TT474: LIVEWIRE - POWER DISCONNECT UPDATE

2020-09-30

APPLIES TO	SYMPTOMS
LiveWire	Power Disconnect

Figure 1. TCU connector

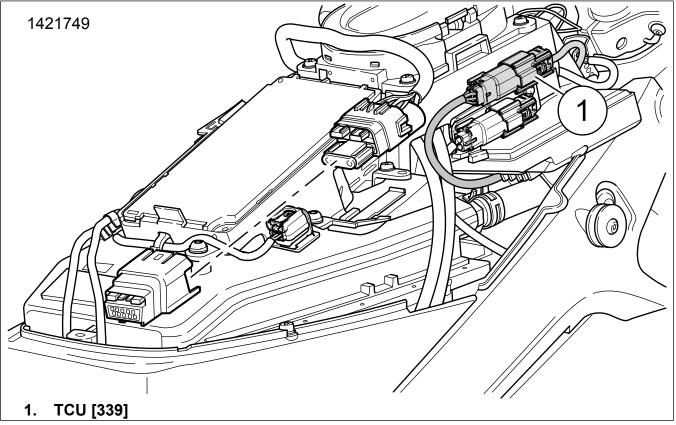
- 1. Remove top cover.
- 2. Remove rear cover.
- 3. Verify that fob is present.
- 4. Place OFF/RUN switch in RUN position.
- 5. See Figure 1. Disconnect Telematic Control Unit (TCU) [339] (1).
- 6. Security siren equipped: Disconnect security siren [142].
- 7. Place OFF/RUN switch in OFF position.
- 8. Wait 5 minutes to allow for proper systems shut down.
- 9. See Figure 2. Disconnect OBC [307-2] (1).

- 1. Verify that OFF/RUN switch is in OFF position.
- 2. See Figure 1. Connect [339] (1).
- 3. If disconnected: Connect [142].
- 4. See Figure 2. Connect [307-2] (1).
- 5. Install rear cover.
- 6. Install top cover.

Figure 2. OBC connector

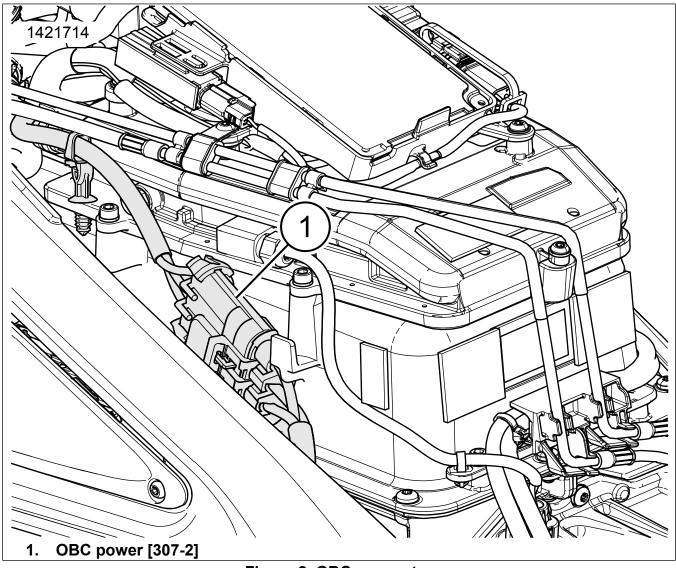
Disconnecting OBC [307-2] and **not** waiting 5 minutes after placing the OFF/RUN switch in OFF position can cause electrical issues including, but not limited to:

Before removing 12 V power or disconnecting any modules, wait a minimum of 5 minutes **after** placing the OFF/RUN switch in OFF position.
